# **Badgerys Creek Quarry Brick Making Project**

### **Traffic Management Plan**

Ref: 21054  
Date: May 2021  
Issue: D

**REVIEW TMP (REV B) - BADGERYS CREEK QUARRY - 235 MARTIN ROAD,  
BADGERYS CREEK**

VEHICLE TURNING MOVEMENTS 1 OF 2

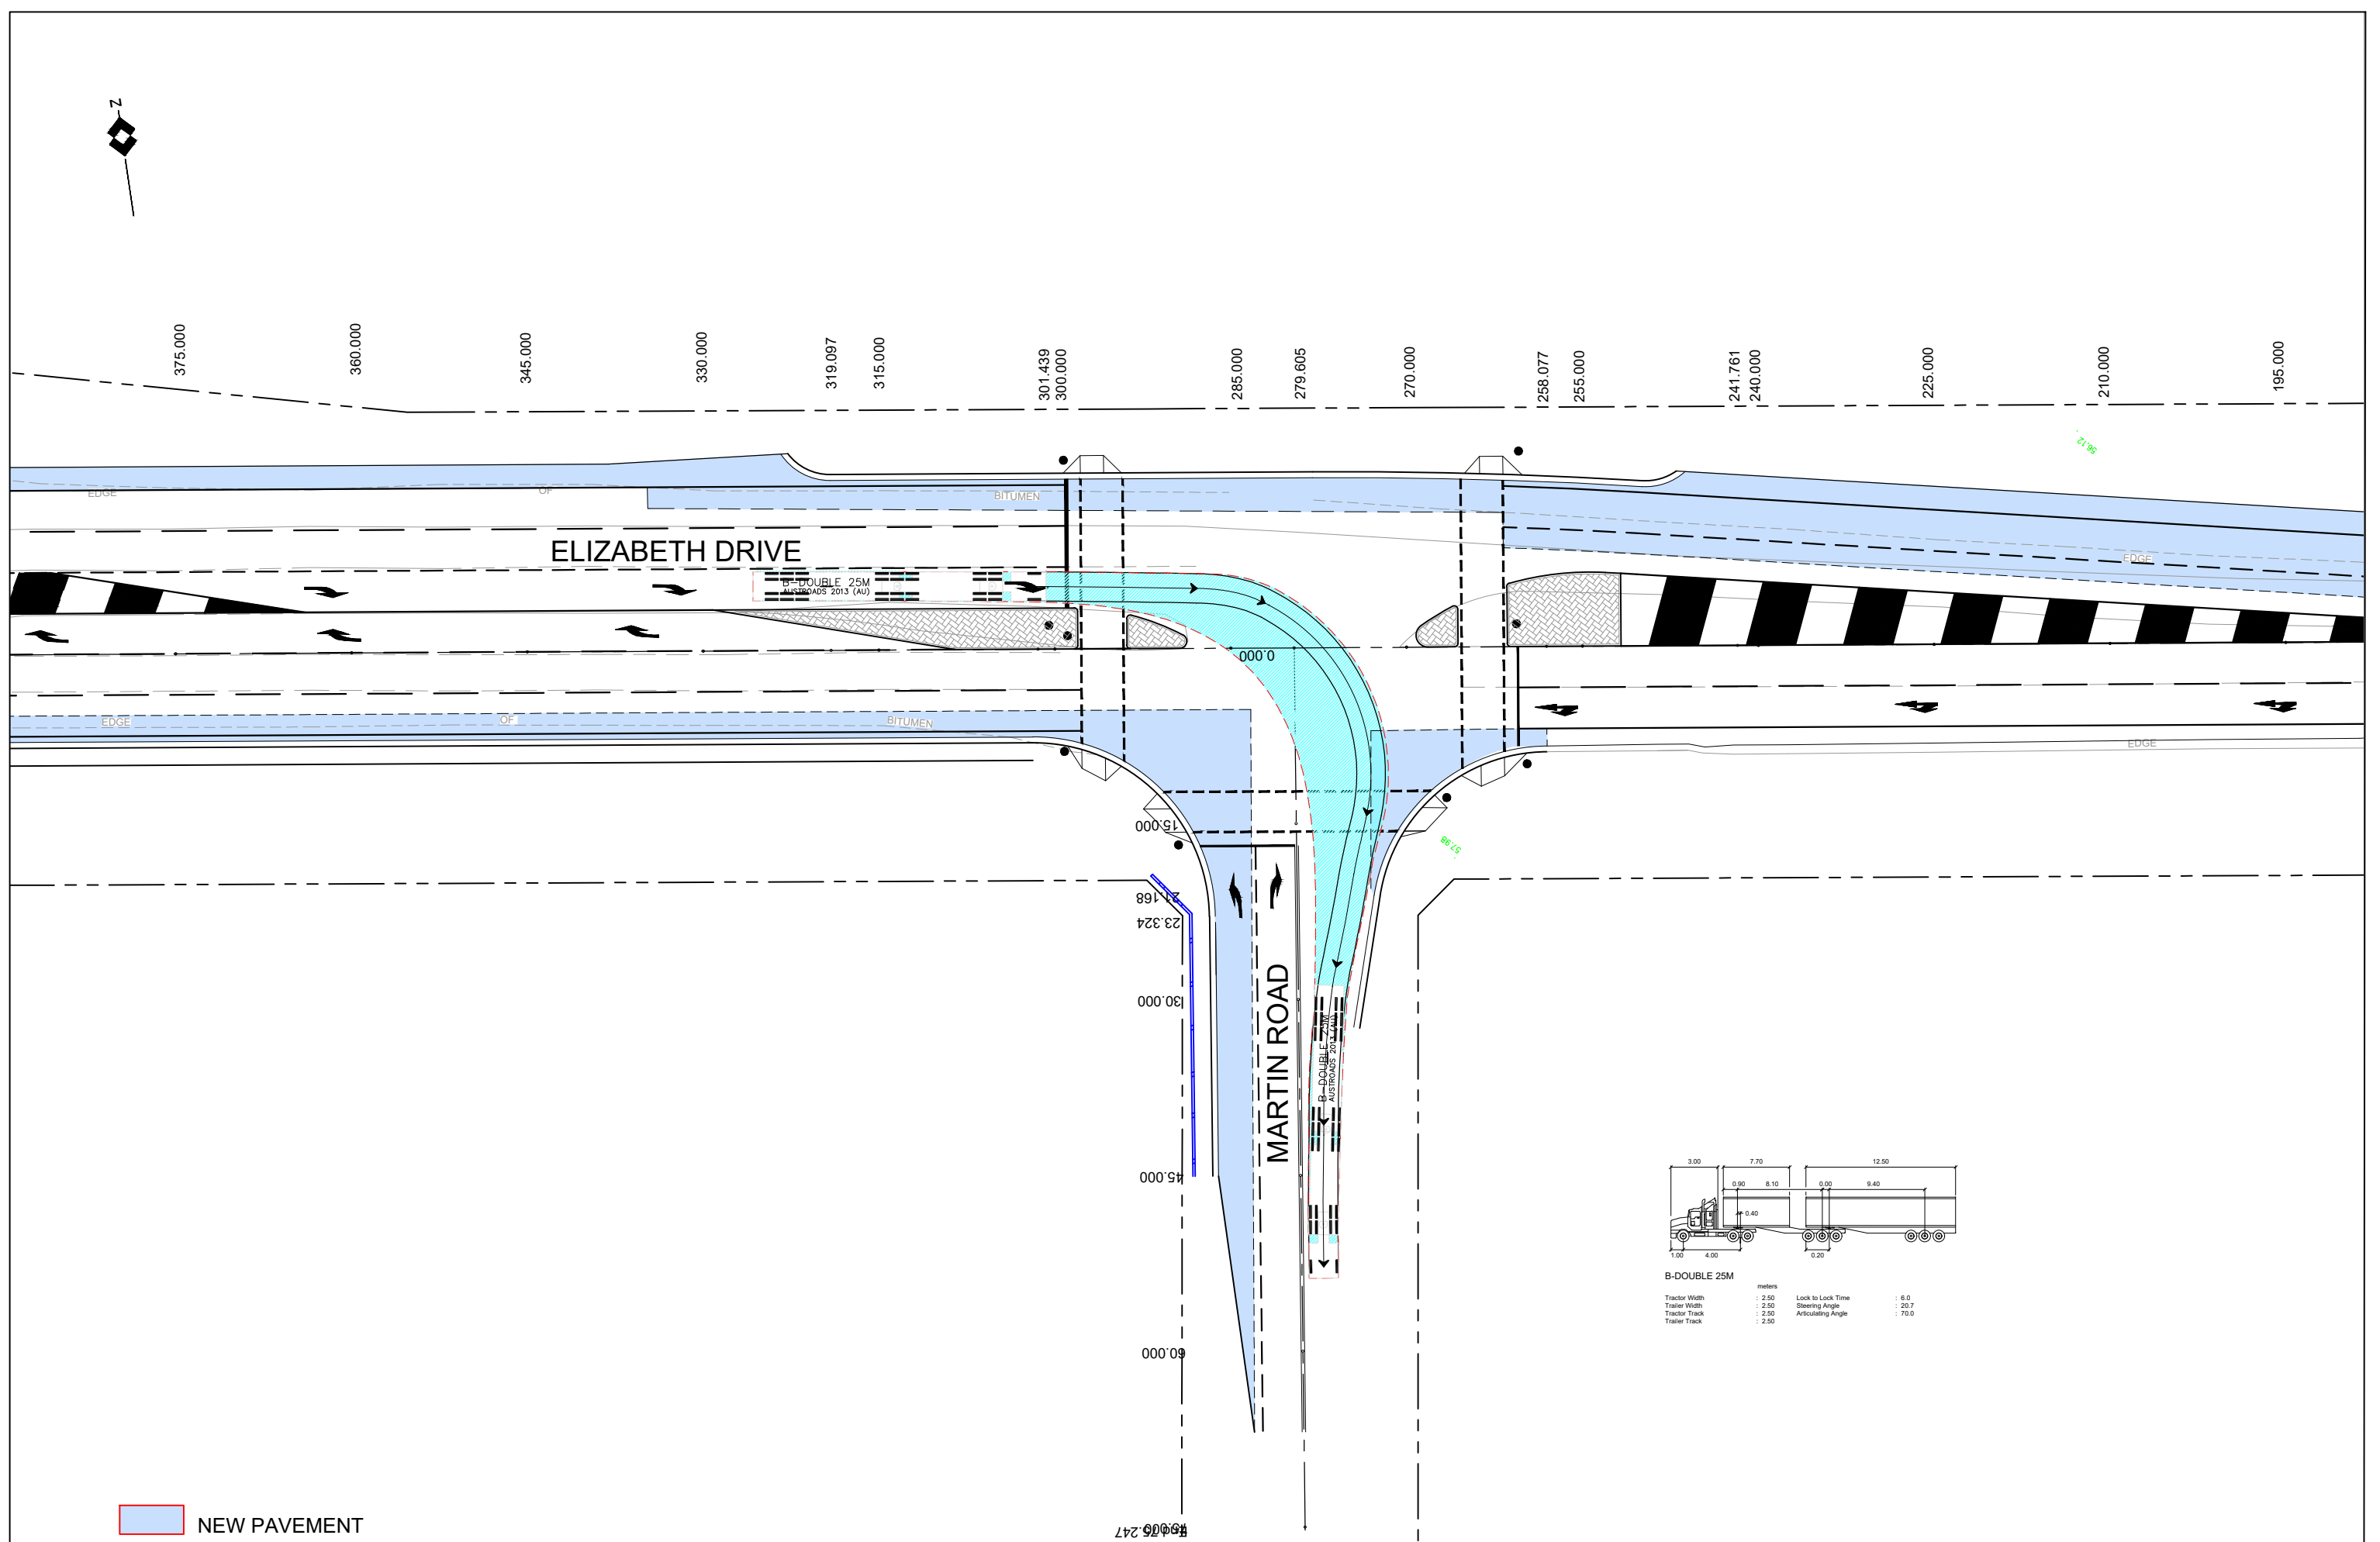
Item	Description	CSR Response	TMP updated
1	The TMP should detail the truck haulage route to and from the construction site	Section 4 has been amended to address this query 'Truck Haulage Routes' and page 15 shows the haulage routes	Section 4
2	The TMP should detail the size and number of trucks used for operation	maximum truck sizes are B-doubles (25m long) and maximum truck numbers are to comply with consent up to a maximum of 200 truck movements a day, section 4 has been amended to include a section on truck details	Section 4
3	The Swept path analysis should be undertaken and demonstrates the largest size of vehicle is able to enter and existing the site in forward direction and negotiate the intersection of Elizabeth Drive and Martin Road without any encroachment.	The intersection upgrade has been designed to accommodate B double trucks (see Diagram A for turning path diagrams)	Diagram A included

### haulage road plan

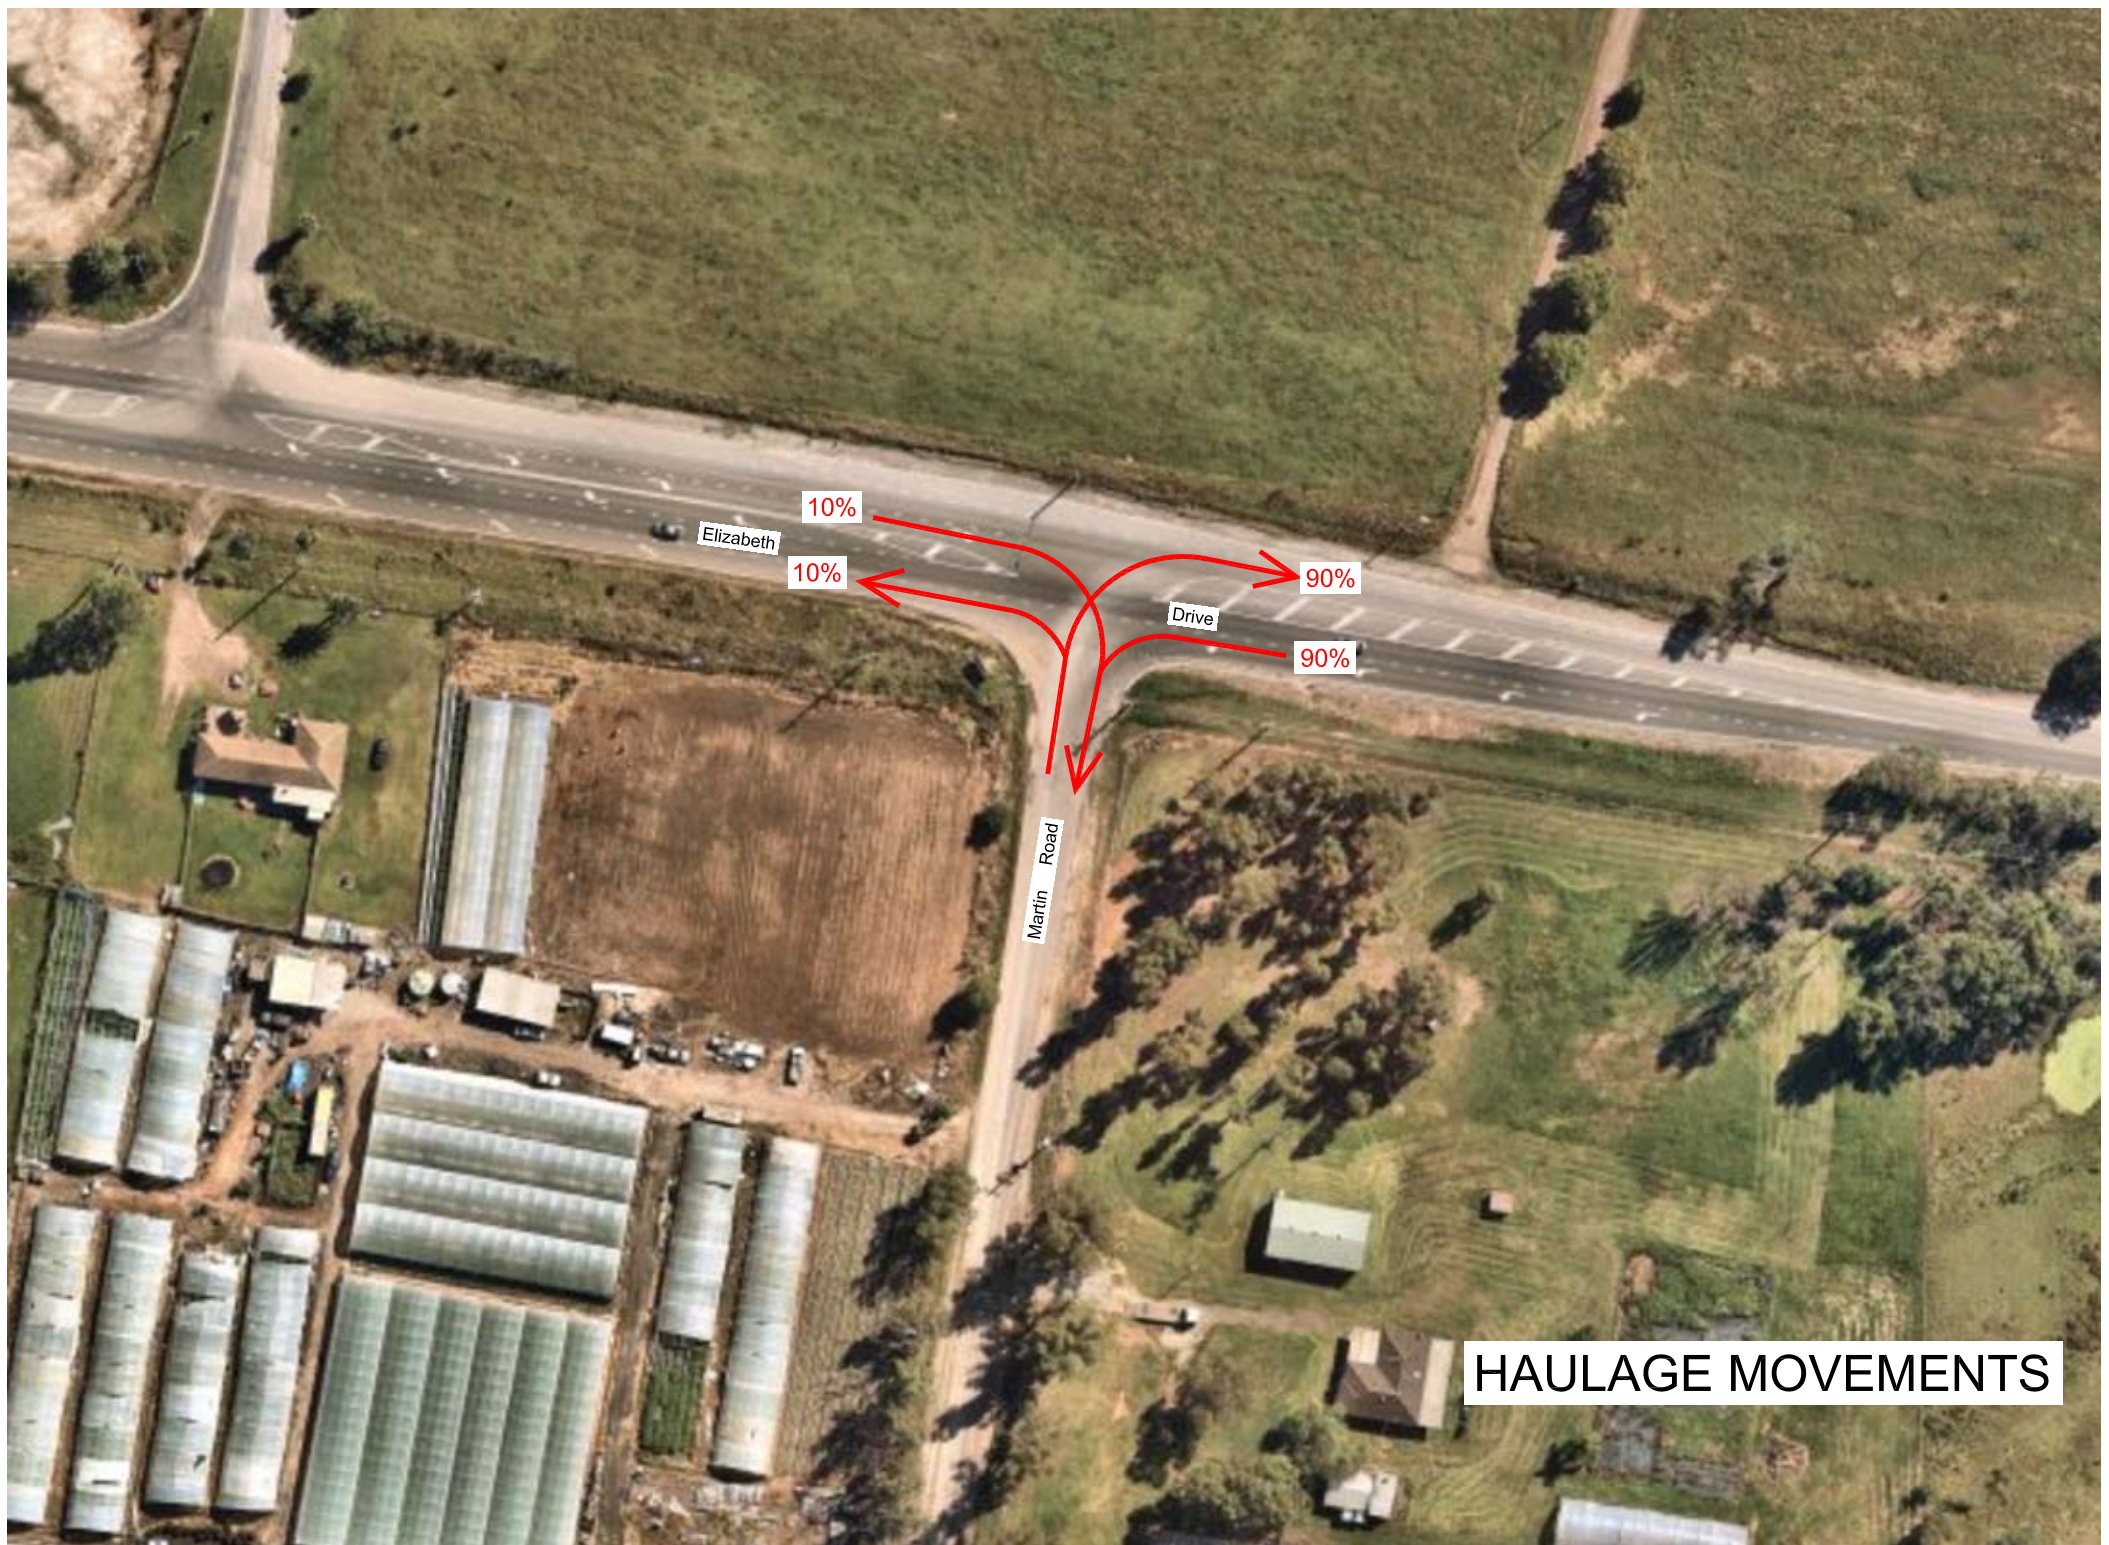
1. Queuing area at least one truck space (i.e. 30 m) is to be provided along the site access road prior to any controlled or boom gates.
2. A plan showing the proposed haulage routes to the subject site is to be included.
3. Details and timing of the proposed Elizabeth Drive and Martin Road intersection upgrade are to be outlined..
4. Temporary car parking area, particularly truck parking area, is to be identified and included.
